Subject: Barrhaven Conservancy West - Hydraulic Impact Assessment

This Memo is related to the Barrhaven Conservancy West lands and specifically addresses comments received as part of the Barrhaven Conservancy West Draft Plan circulation, notably, comments 4.5 and 4.6 prepared by the RVCA.

PROJECT :
 Barrhaven Conservancy Abeyance Land
 - Hydraulic Impact Assessment

TITLE :
 Figure 1-1
 Peak Water Level Difference:
 2D RVCA Proposed Abeyance Lands (v22.2) - 2D 2019
 Approved Development (v22.1)
 (100 Year Flow - 196 cms)

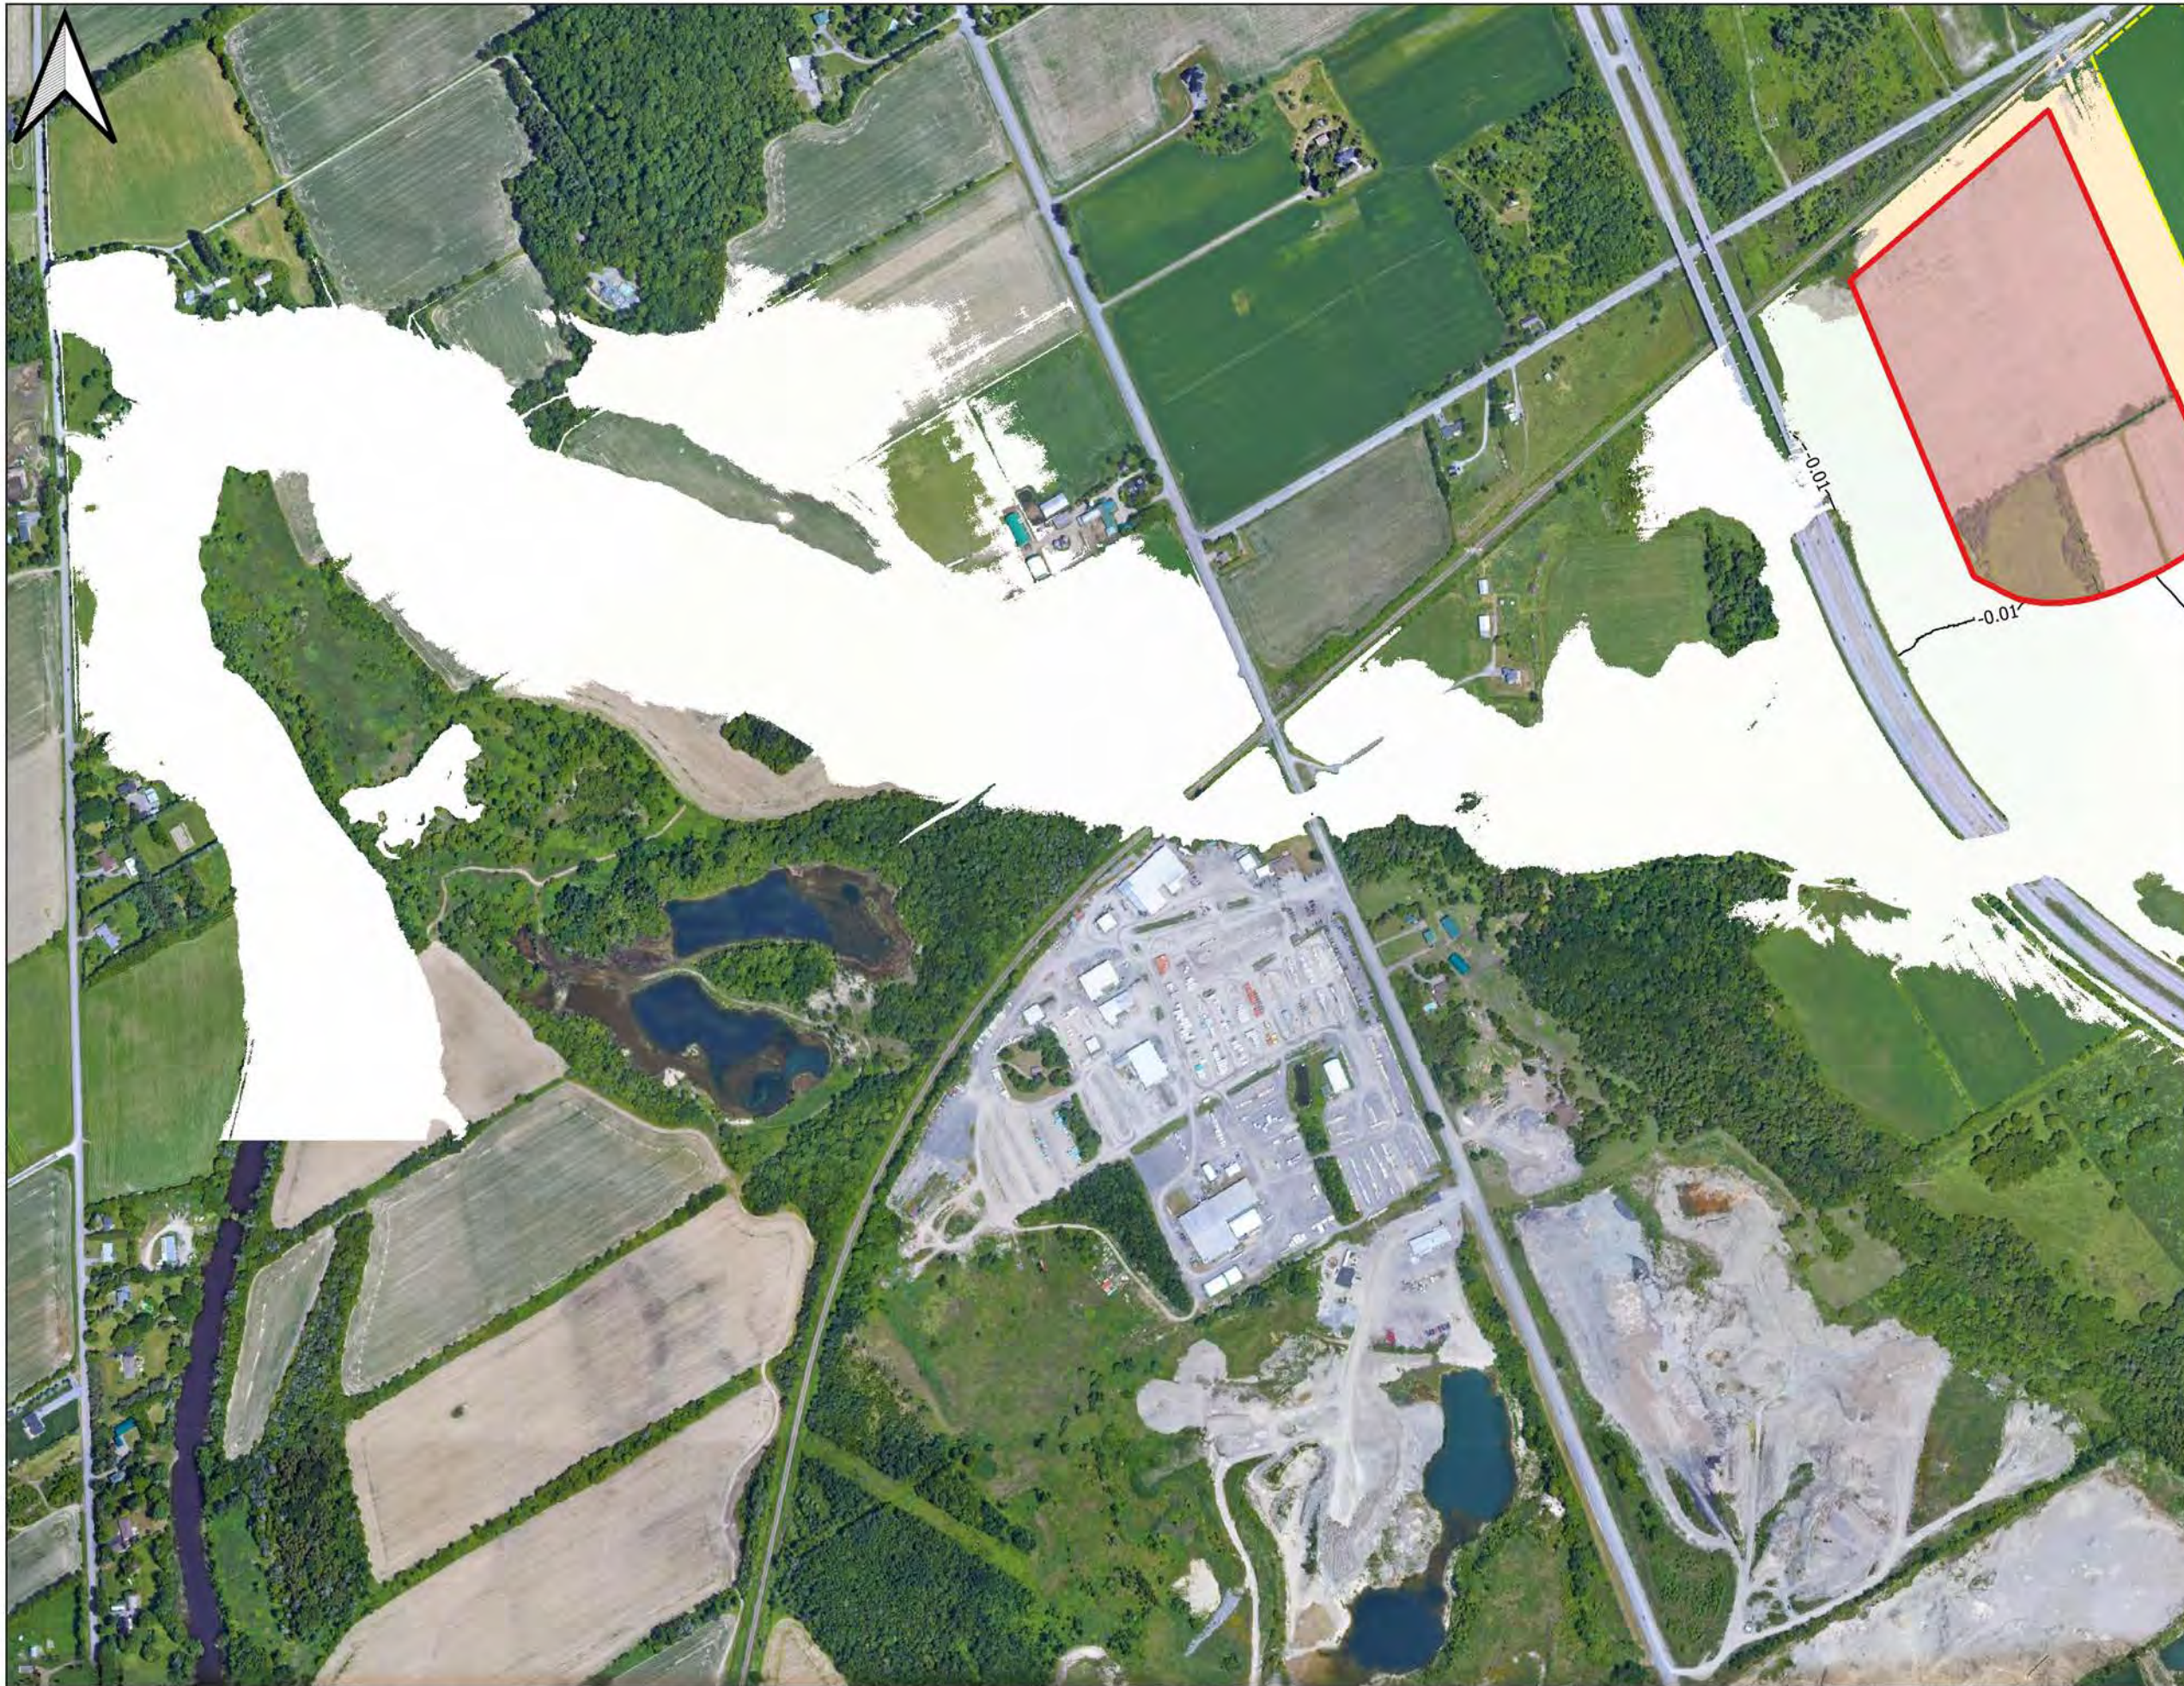
4.5. Further, as part of the RVCA letter of permission (RV5-4419) for flood plain modifications, a monitoring program has been initiated as a condition of approval. As part of the monitoring program, it has been anticipated by the Conservation Authority that portions of the proposed subdivision are to be held from development as a potential area for modification should the monitoring program identify a need for additional cut be required. Portions of the lands west of the current O'Keefe alignment were identified as being the optimal location to provide additional cut should it be required. As such, development of these lands should be held in abeyance, until the monitoring program has been completed and that an additional cut is demonstrated to not be required. [emphasis added]

Figures 1-1 to 1-4 provide flood plain difference maps for the 100-Year flood comparing:

The difference maps have been produced by subtracting the peak computed water levels of approved 2019/2020 2D conditions from the 2D RVCA potential mitigating conditions. To illustrate the results, increases and decreases in the flood plain peak water level differences have been represented in light red (increases) and light blue (decreases), respectively. Water surface difference contours have been overlaid on this figure at 1 cm increments to provide context to the applied raster palette.

This analysis demonstrates that the lands proposed by the RVCA to be held in abeyance have a very limited impact on the water levels of the Jock River, with a localized **1 cm** decrease upstream of these lands when compared with the approved condition. There is also a localized increase of **2 cm** near the O’Keefe Drain, which is due to flows from the Jock River being able to flow directly to this location (which was previously protected by the filled parcel). As indicated in this figure, the lands proposed by the RVCA to be held in abeyance have a very limited mitigating effect on peak water levels on the Jock River when compared to the expected results presented in the JFSA October 2019 report.
